2.5 Geology, Seismology, and Geotechnical Engineering

In Section 2.5, "Geology, Seismology, and Geotechnical Engineering," of the SSAR, SERI provided a detailed description of the geological, seismological, and geotechnical engineering properties of the ESP site. In this SER, Section 2.5.1, "Basic Data," describes basic geological and seismological data, especially the data published since 1986 for the area within a 200-mile radius of the ESP site, and presents updated seismic sources. Section 2.5.2, "Vibratory Ground Motion," evaluates the vibratory ground motion for the ESP site and analyzes the safe-shutdown earthquake (SSE) ground motion. Section 2.5.3, "Surface Faulting," describes the potential for surface faulting at or near the surface of the ESP site. Section 2.5.4, "Stability of Subsurface Materials and Foundations," presents the results of site geotechnical investigations and discusses the stability of subsurface materials and foundations. Section 2.5.5, "Stability of Slopes," defers the analyses for slope stability at the site and dam performance, respectively, to the COL stage. Finally, Section 2.5.6, "Embankments and Dams," briefly states that no embankments exist wi

**Figure 2.5.4-13 (Figure 2.5.4-4-1 of the RAI response)
Deep Profiles for Sensitivity Analyses**

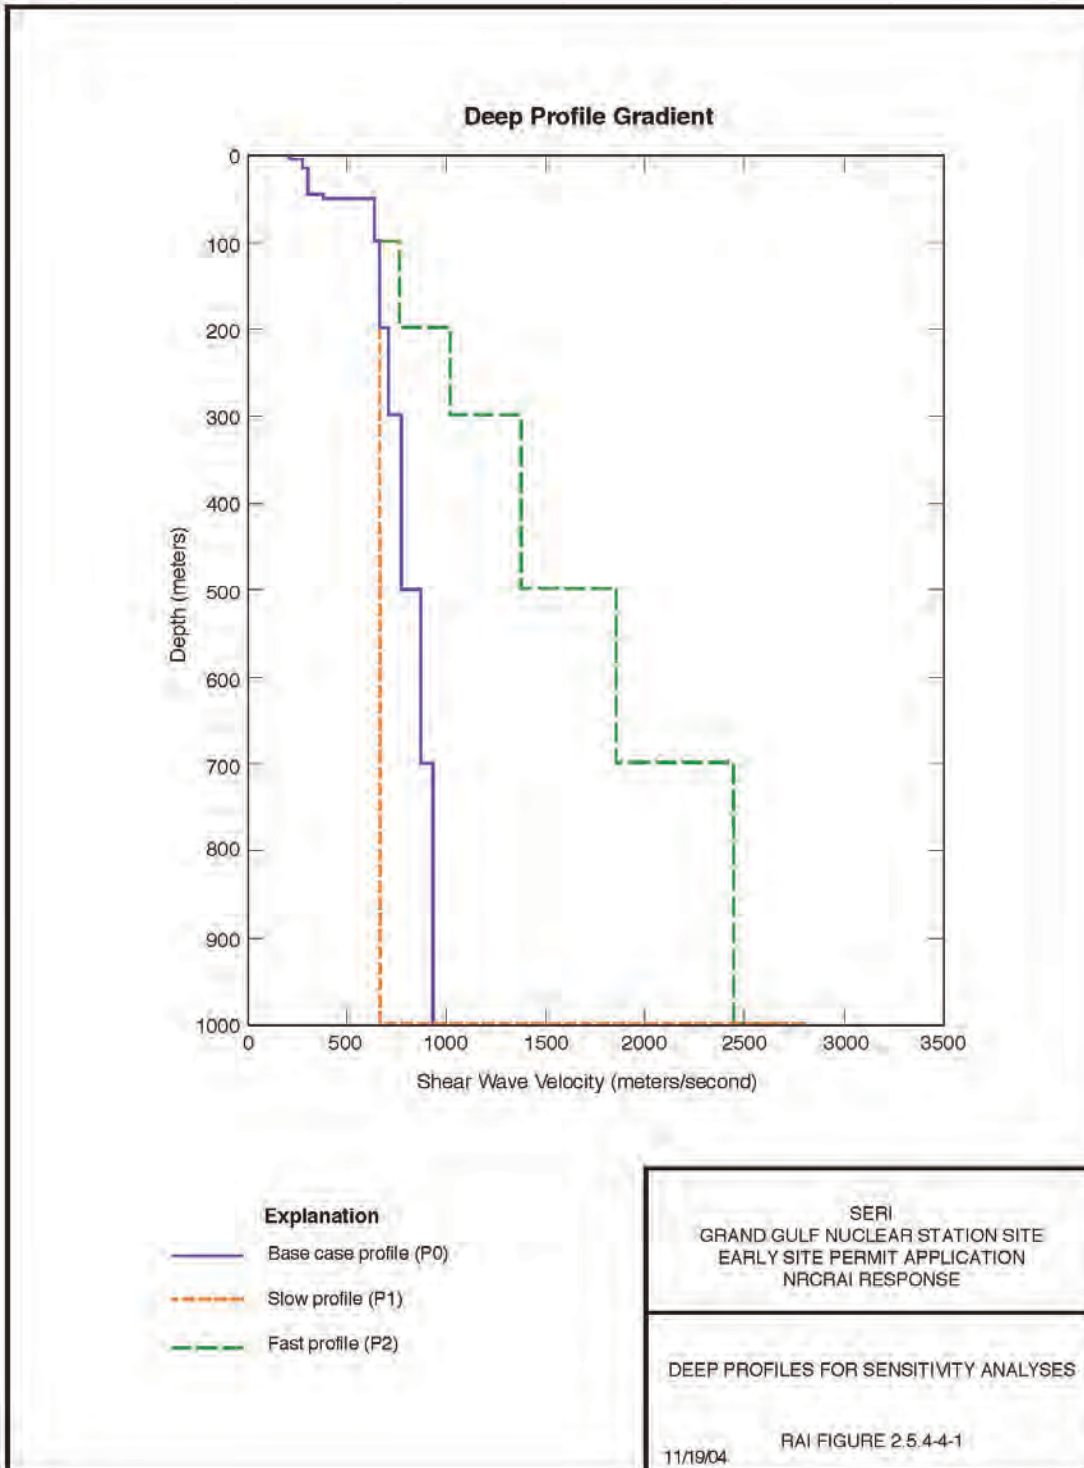
In seismic response analyses, shear and compression wave velocities, material densities, and strain-dependent modulus reduction and hysteretic damping data are necessary for the entire soil column extending to the depth considered in the site response evaluation. As indicated in Figure 2.5.2-4, the applicant assumed that the hard rock, with a shear wave velocity of 9186 fps, is located at a depth of 3281 feet and adopted a generic profile proposed for the Mississippi embayment region. This shear wave profile is relatively smooth, with a shear wave velocity varying from approximately 820 fps at the ground surface to a value of 9186 fps at a depth of 3281 feet. The applicant also replaced the upper 197 feet of the profile with a site-specific velocity profile generated by the geophysical program described previously. Therefore, of the entire 3281 feet of the profile, only the upper 197 feet are reasonably constrained. No site-specific information is available below this depth. However, it is a common practice for the sites where critical facilities are located to have one or more base case shear wave velocity models from site-specific data (e.g., well logs and deep borings) and then to generate soil UHRS using the probabilistic method of NUREG/CR-6728. In RAI 2.5.4-4, the

Figure 2.5.4-13 shows the base case shear wave velocity profile to the analysis depth of 1 kilometer along with two extreme cases for extrapolation to the hard rock shear wave velocity of 2.8 km/s. The slow profile assumes a uniform extension of the velocity just beneath the site to 1 kilometer, with a jump to the hard rock value of 2.8 km/s. As another extreme alternative, the fast profile assumes a linear (modeled as a stair step) gradient with depth, reaching 2.8 km/s at a depth of 1 kilometer. Based on general experience with measured shear wave velocity profiles in large sedimentary basins, the applicant expected the slow and fast profiles to reflect extreme (i.e., low likelihood) conditions, particularly with regard to the local and regional overall geology.

To compare the median motions computed for the three profiles, the applicant stated that it used the 1- to 2-Hz-scaled 10^{-5} APE spectrum as the control motions to excite the column at low as well as high frequency since it is quite similar to the UHRS and sufficiently broad band (i.e., large magnitude) compared to the UHRS. Figures 2.5.4-14 and 2.5.4-15 show the resulting soil median motions in both the logarithmic and linear spectral axes, respectively. As expected, little difference exists between the motions computed for the three profiles from 0.3 to 100 Hz. At peak acceleration, the fast and slow profiles show about a 5-percent increase and decrease, respectively, in motions, as compared to the base case profile. The motions reflecting the fast profile generally exceed those of the base case by about 5 percent. The largest exceedance is near a resonance at about 3 Hz, at which the fast profile motions exceed the base case motions by about 10 percent. Based on regional geology as well as experience with similar geology in deep basins, this fast profile is extremely unlikely and would receive very low weight in a hazard analysis. The applicant stated that these site response analyses illustrate the general insensitivity of the motions to the nature of velocity gradients likely to exist in the deep materials beneath the site.

Figure 2.5.5-1 (RAI Figure 2.5.5.1-1)
 Schematic Section Showing Relationships
 Between Loess Bluff Slide and ESP Site

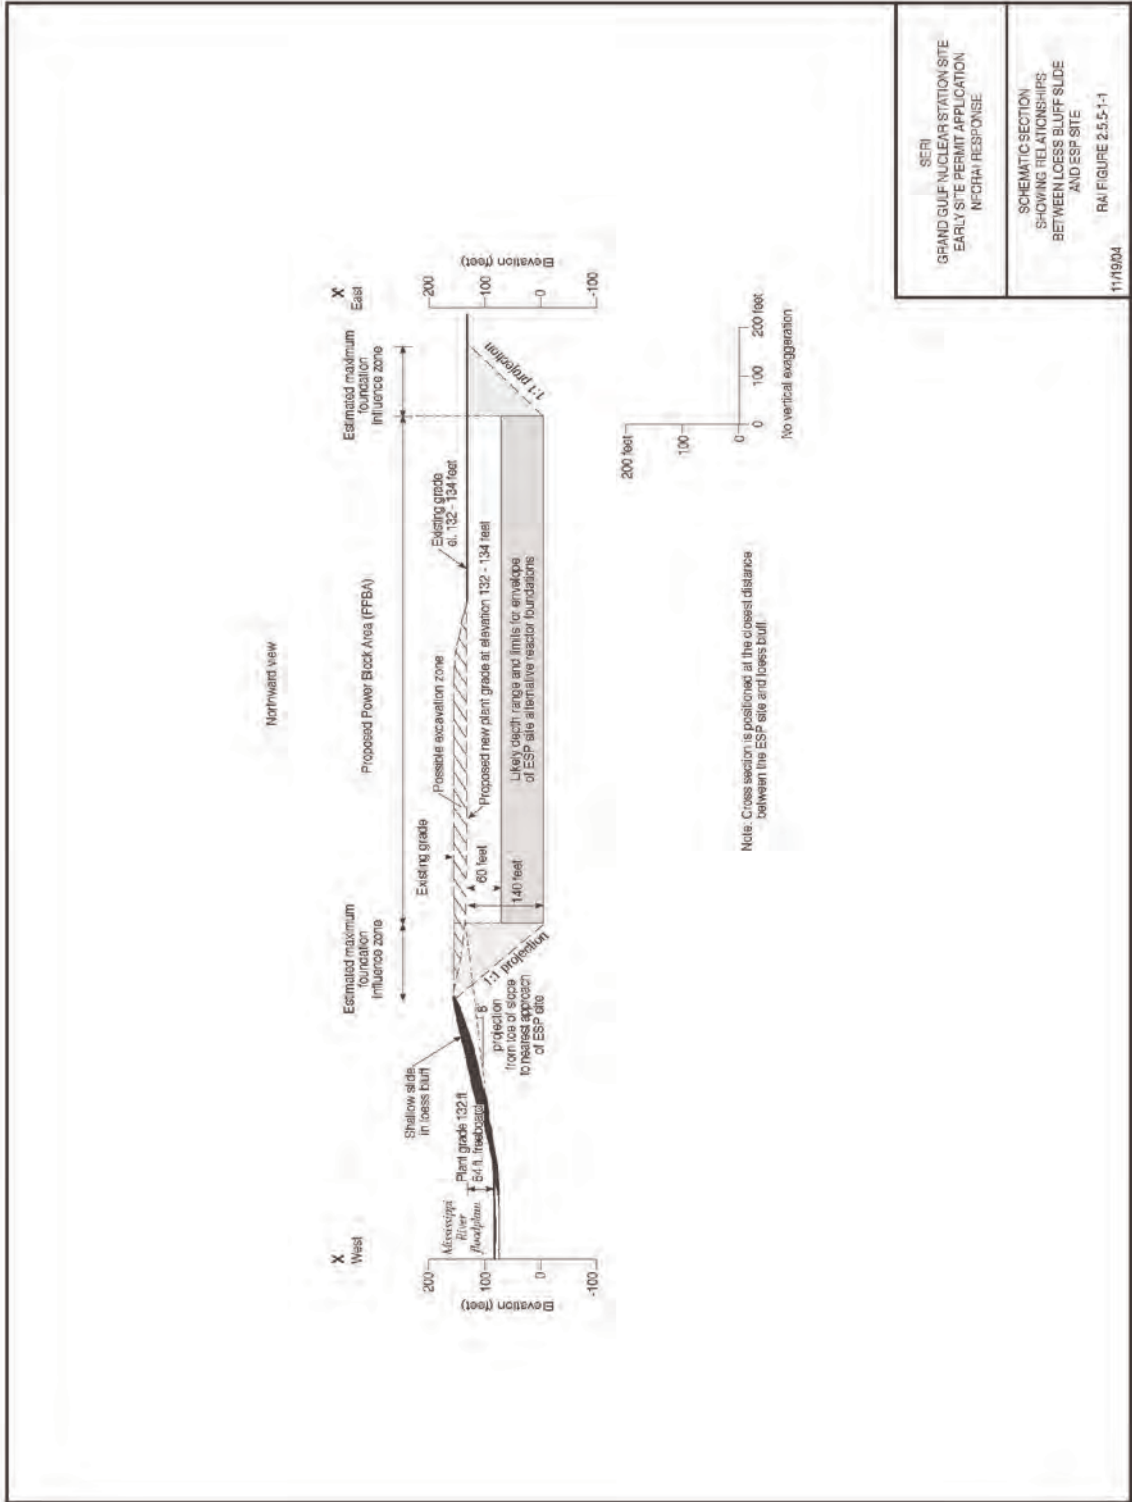
As stated in the SSAR, no plans exist to perform specific analyses to evaluate the stability of deep foundation excavations for the future facilities at the proposed ESP site until the COL phase. In addition, the applicant stated that it did not find any indications of unstable materials underlying the site that should cause unusual stability conditions for excavations and excavation support. In SSAR Section 2.5.5 and Sections 3.3 and 12.5.2 of ER-02, the applicant noted that a 60–70-foot escarpment that may be subjected to surficial slumps and potential creep of the loess soils bounds the west side of the proposed ESP site. The applicant further stated that, since future safety-related facilities would be founded on Upland Alluvium or Old Alluvium encountered below the loess, future movements of the slope should not have any significant impact on these foundations. However, if such facilities are founded close to the scarp, such slump or creep effects could have an impact on lateral loads applied to such deeply founded facilities. In RAI 2.5.5-1, the staff asked the applicant if it had performed any evaluation to indicate the expected behavior of the loess escarpment or the extent to which such movements could occur. In addition, the staff also asked the applicant if the ESP site should have some exclusionary zones along the west-side boundary that would not be susceptible to such potential future slump. In its response, the applicant stated that SSAR Figure 2.5-69 shows the spatial relationships among the PPBA and the loess bluff and the postulated shallow slump in the bluff near the west boundary of the ESP site. The applicant evaluated the potential hazard to the site from slope failure and creep in the loess bluff by examining geologic cross-sections, evaluating embedment depths and positioning of ESP structure foundations, and qualitatively assessing the bluff slope stability in relation to the relative strength of subsurface materials. The applicant further stated that it developed a simplified cross-section to show the geometric relationships between the loess bluff and the site. In this schematic cross-section, the PPBA is set back over 100 feet from the closest approach of the bluff and top of the postulated slump. The maximum foundation influence zone envelope extends to just within the headscarp of the slump area. However, the likely depth range for the prospective reactor foundations required to satisfy minimum embedment and shear wave velocity criteria places the foundation level about 10–80 feet below the elevation of the toe of the bluff slope. The applicant also stated that it is unlikely to develop a failure plane that extends from the toe of the bluff or headscarp of the postulated slump back to the PPBA. A failure plane would have a very gentle inclination of about 8 degrees and would need to intercept the perimeter of the PPBA at least 5–10 feet below plant grade. The applicant believed that such a low-angle failure plane is very unlikely based on an estimated in situ effective friction angle of 33–34 degrees measured by triaxial UC

testing of loess samples. Therefore, the applicant concluded that no kinematically feasible bluff failures could extend back to, or negatively impact, the stability and lateral confinement of prospective reactor foundations within the PPBA. Based on the qualitative stability assessment, the hazard to the ESP site from possible future movements in the loess bluff is very low to none and does not require additional analysis at this ESP stage. The applicant stated that an exclusionary zone between the top of the bluff and the ESP PPBA, therefore, is not necessary.
